CITY OF ALBUQUERQUE

Re: Building A & Building B
543 Old Coors Rd. SW
Traffic Circulation Layout
Architect's Stamp 07-21-22 (K11-D027)

Based upon the information provided in your submittal received 08-24-22, the above referenced plan cannot be approved for Building Permit until the following comments are addressed:

SITE DETAILS

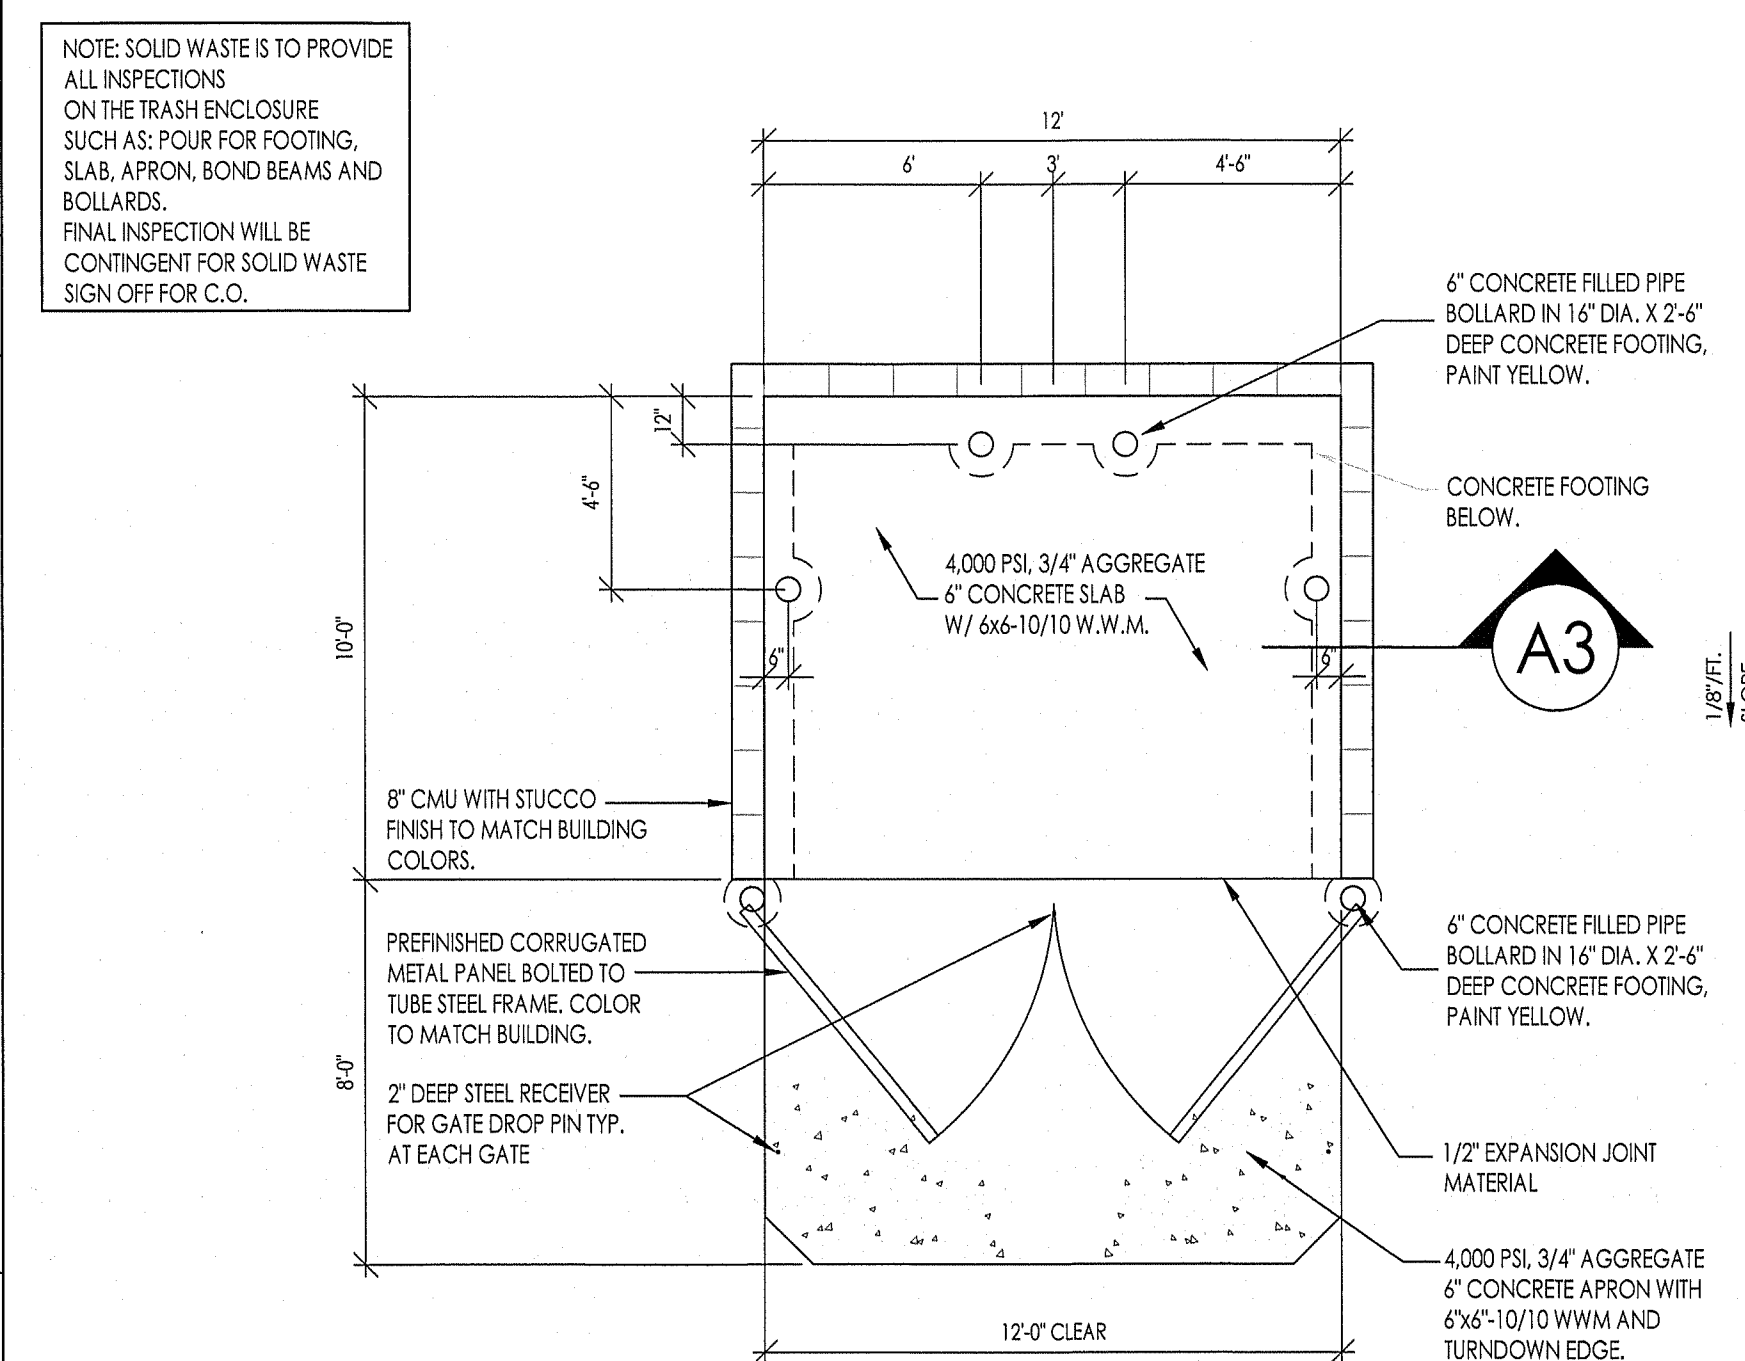
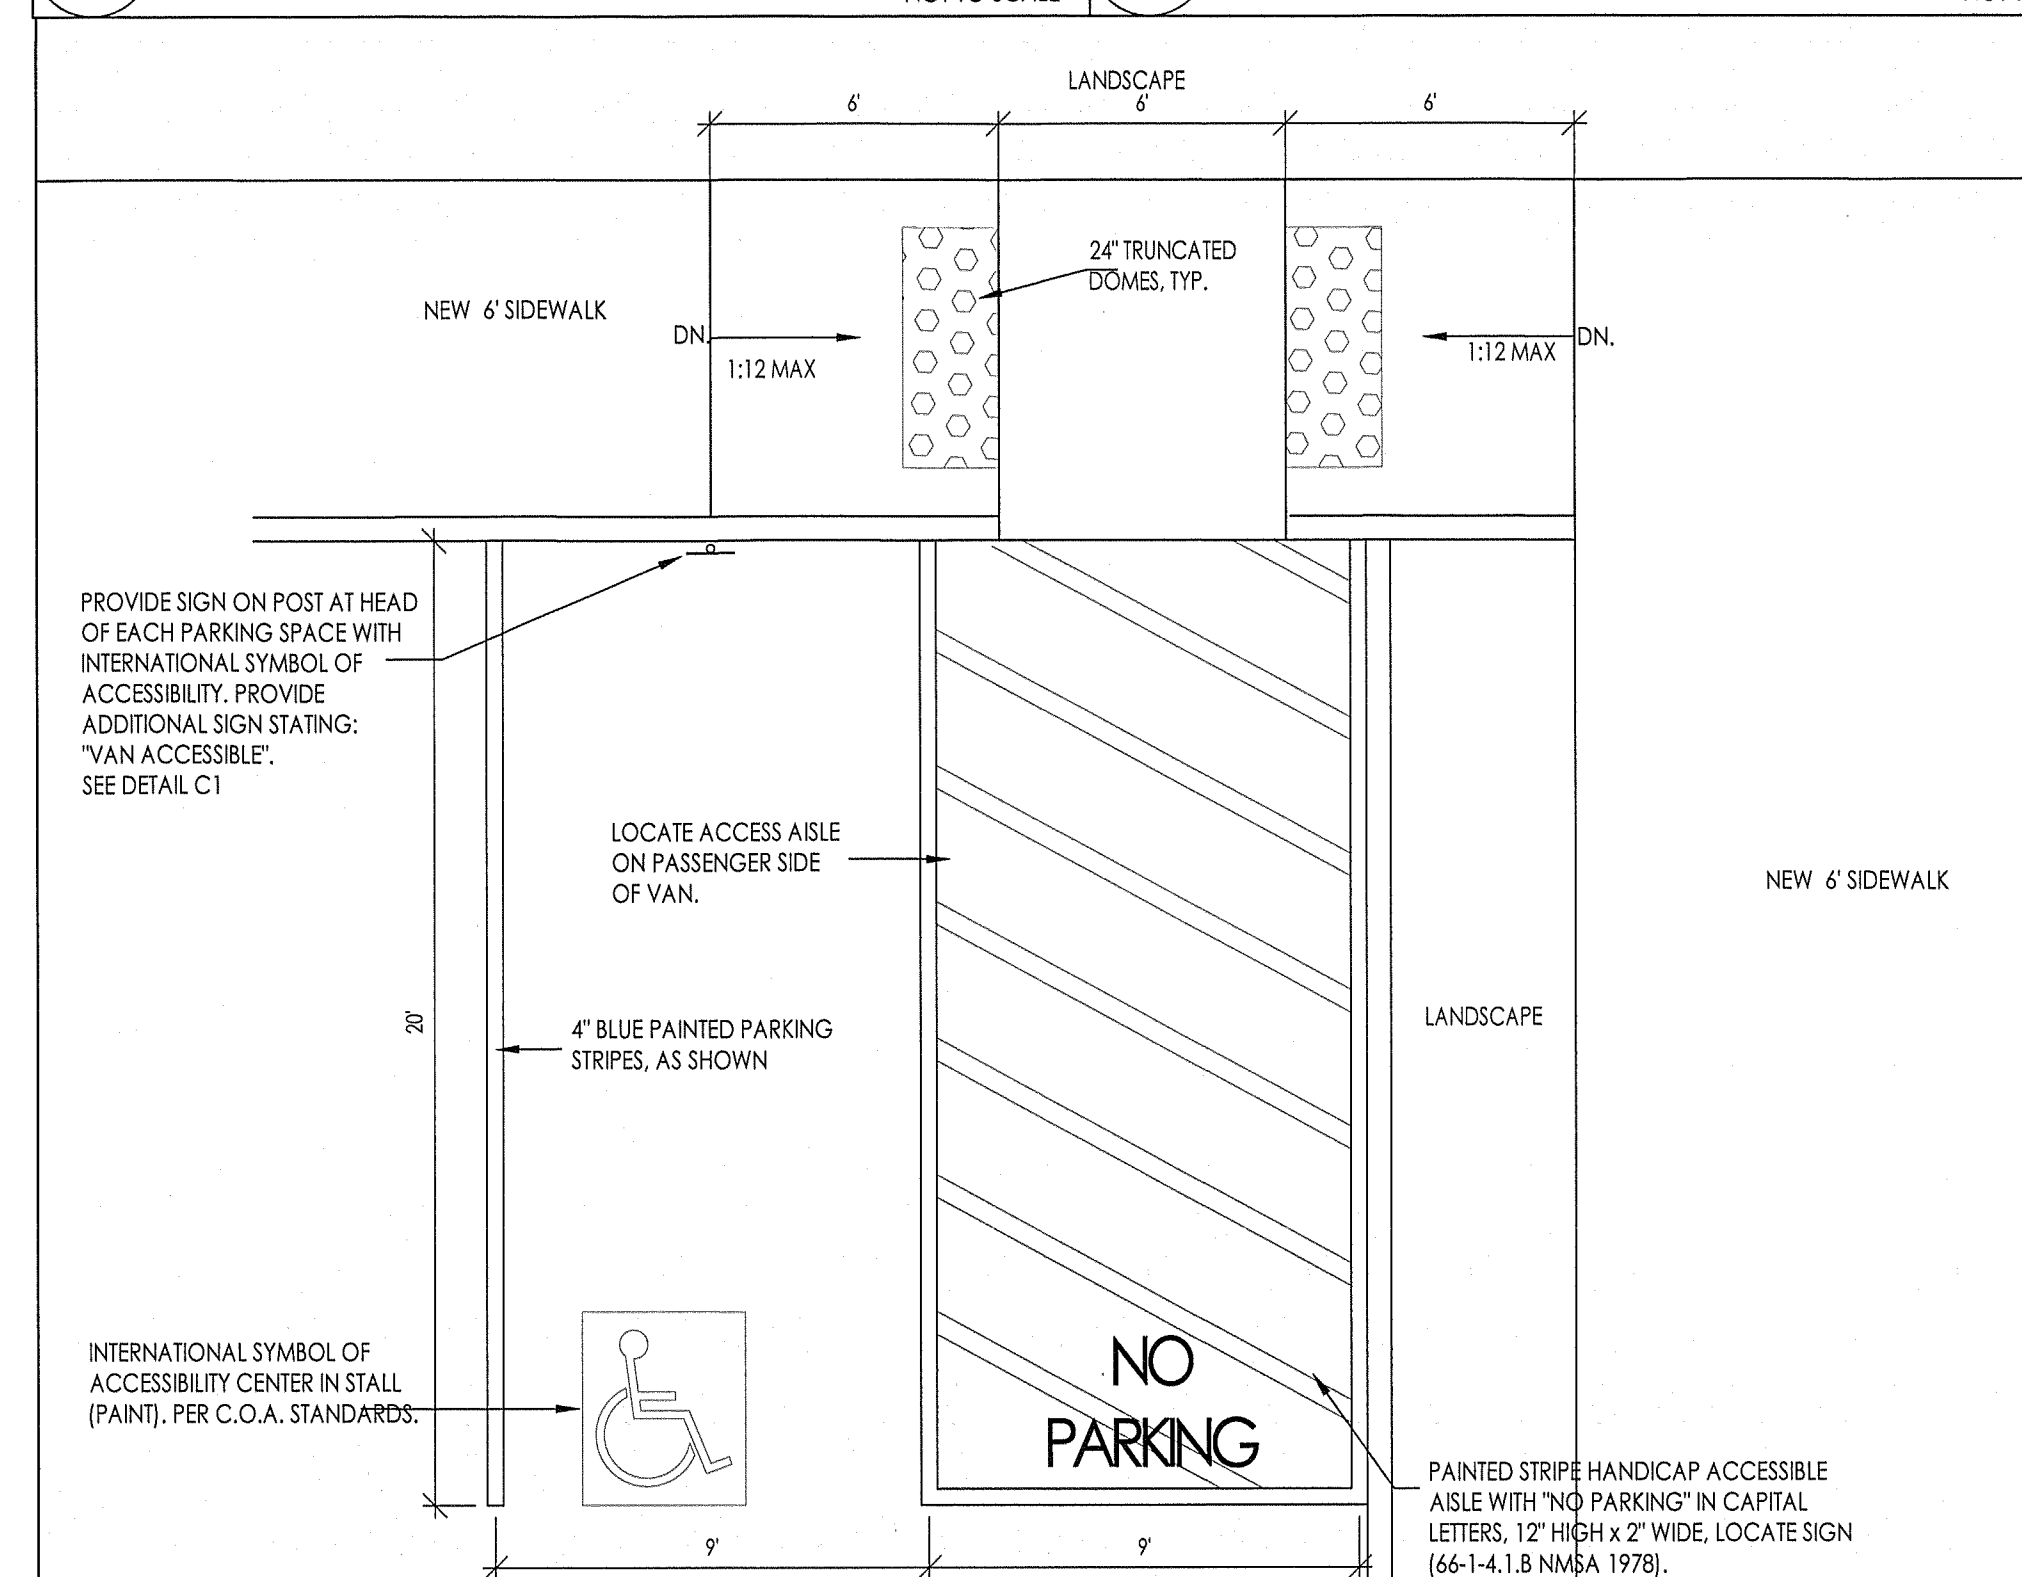
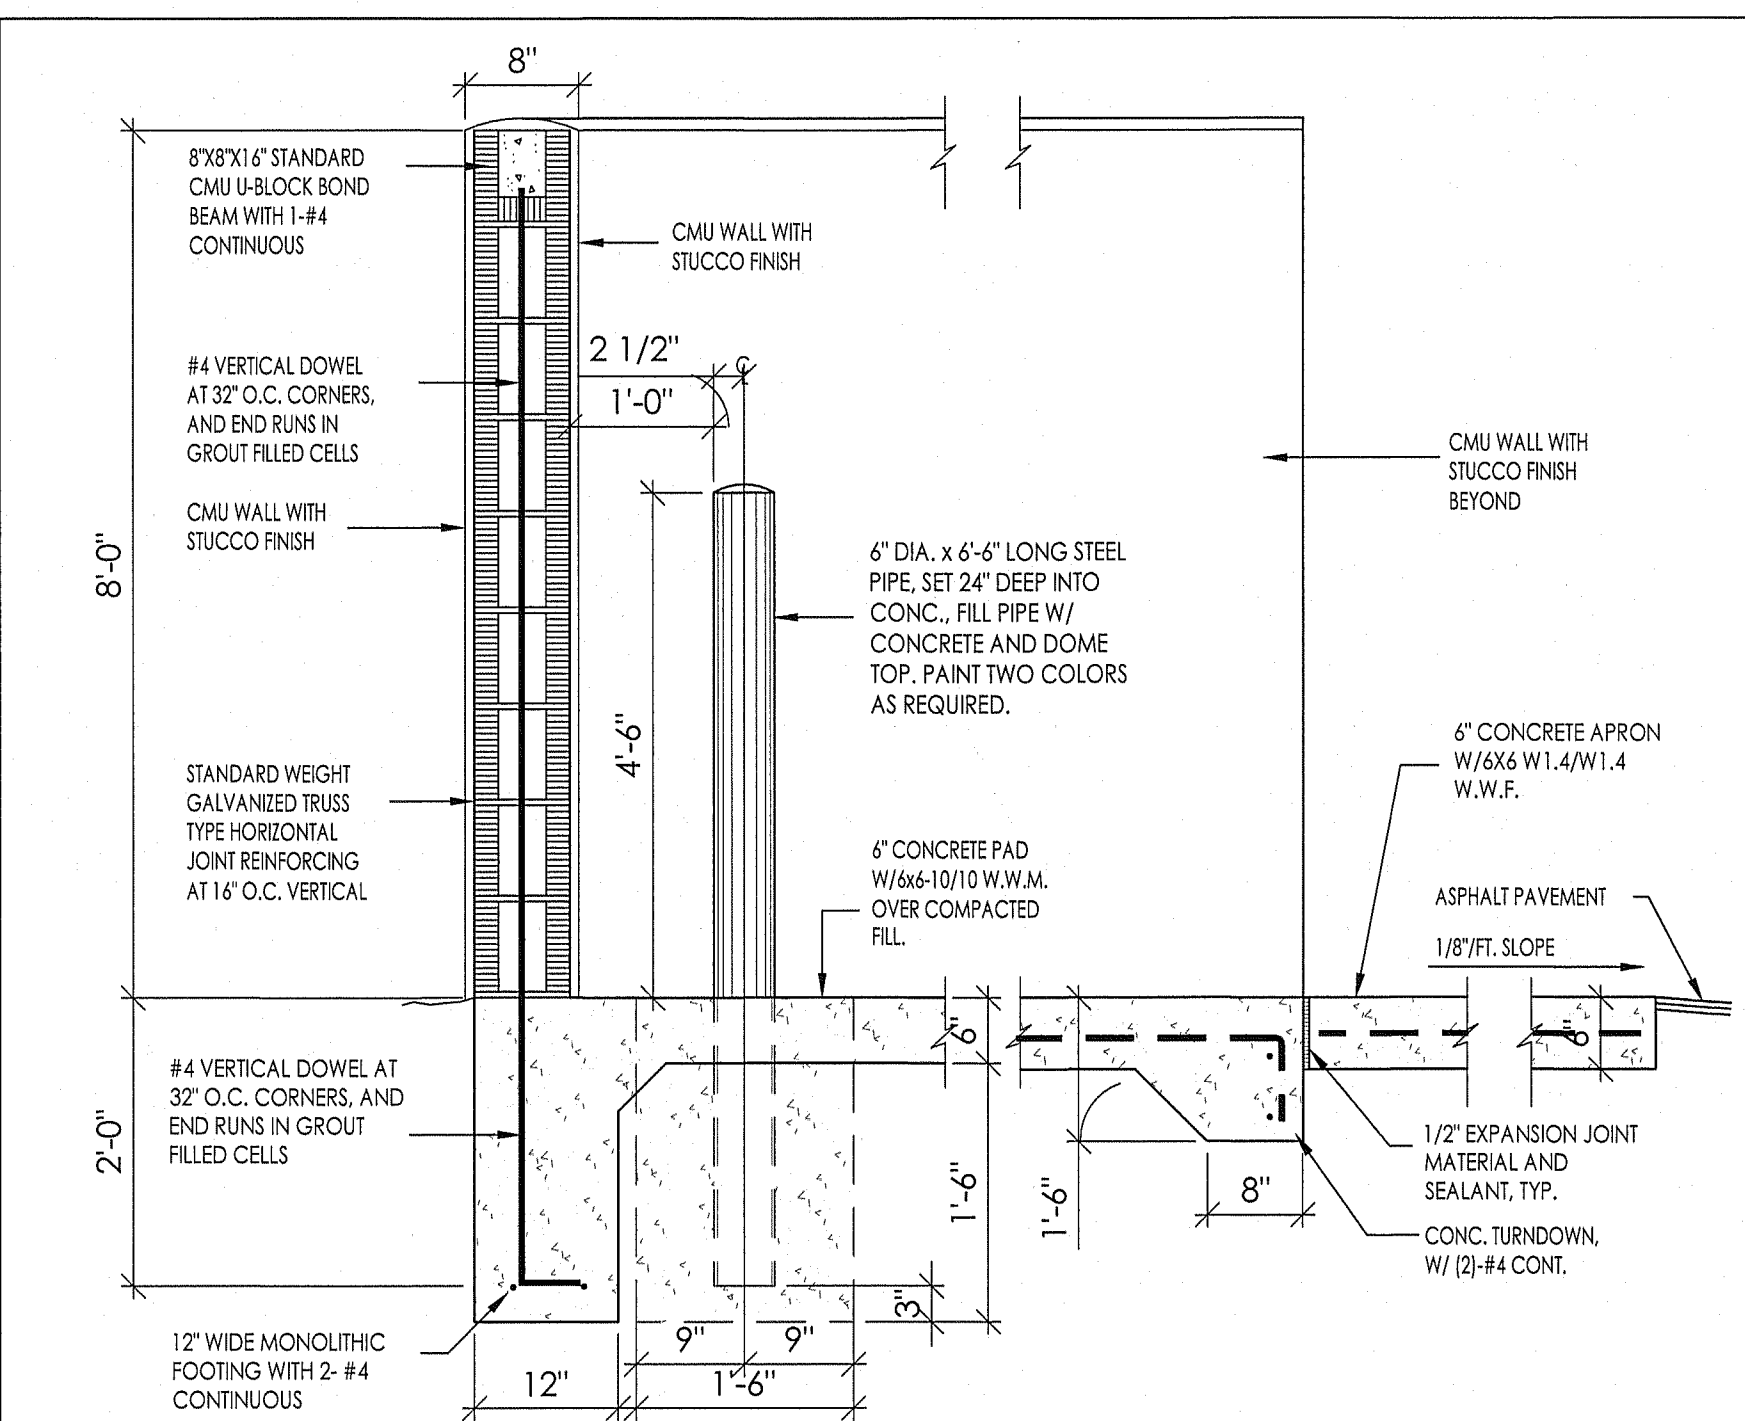
5. Sheet details (the detail A7), where is the location for this ramp on the site plan? Please note that he landing area dimensions should be min. 5' x5'
